CERTIFICATE OF APPROPRIATENESS

Property: 536 Harvard Street, lot 21, block 289, Houston Heights Subdivision. The property includes a historic 2,808 square foot four-plex apartment building and a detached garage situated on a 6,600 square foot (50' x 132') interior lot.

Proposal: Alteration – Construct a 576 square foot rear addition to the rear of a contributing four-plex as part of converting the property to a single family home. Revise the front façade to replace three existing doors with two windows and a single glass panel door. Replace existing round porch columns with new square columns.

HAHC Action: **Approved with Conditions: Retain the center front door and both porch columns.**

WEST ELEVATION – FRONT FACING HARVARD STREET

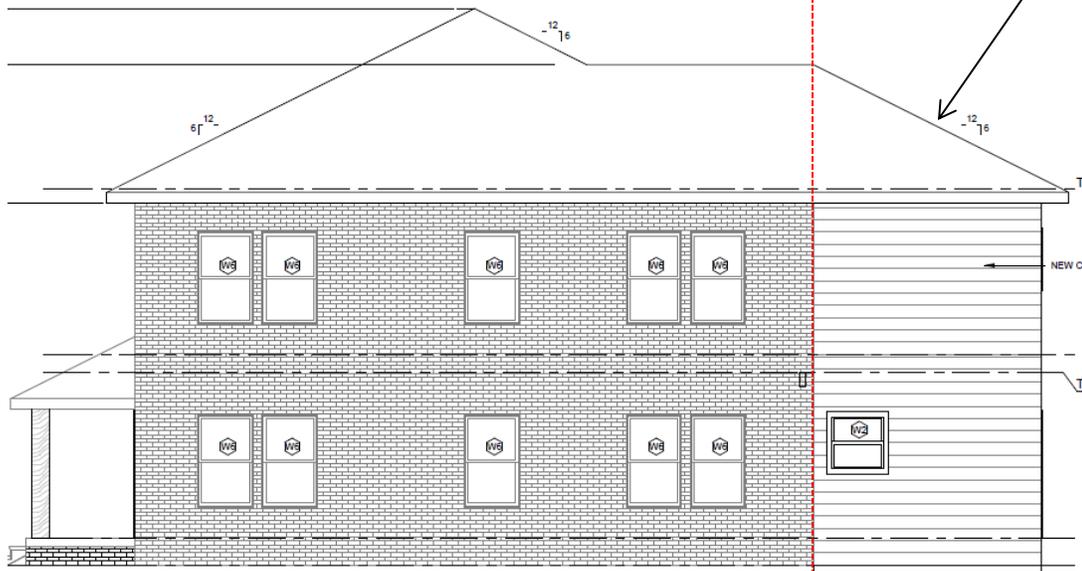
- (1) The proposed activity must retain and preserve the historical character of the property;
The replacement of historic round columns with square columns, and the replacement of a historic wood grid divided lite front door with a new glass panel door, undermines the historic character of the property. Both the existing columns and door are character defining historic fabric and are in good condition.

- (4) The proposed activity must preserve the distinguishing qualities or character of the building, structure, object or site and its environment;
The existing round columns and front door are in good condition and are components of the existing apartment building's character. Replacing them discards these distinguishing qualities.

- (5) The proposed activity must maintain or replicate distinctive stylistic exterior features or examples of skilled craftsmanship that characterize the building, structure, object or site;
The proposal to replace the existing center front door and columns fails to maintain these distinctive exterior features.

- (9) The proposed design for any exterior alterations or addition must not destroy significant historical, architectural or cultural material and must be compatible with the size, scale, material and character of the property and the area in which it is located;
The proposal to replace the center front door and porch columns represent a loss of significant historical material. These materials are in good condition. In addition, the use of a proposed glass panel door and square columns in place of the original divided lite door and round columns, is not compatible with the character of the existing apartment building.

Replace existing round porch columns with square columns

Replace three existing front doors with a new center front door and two fixed windows

Recommendation: **Conditional Approval: Approved on the condition that the applicant retains the center front door and both porch columns.**
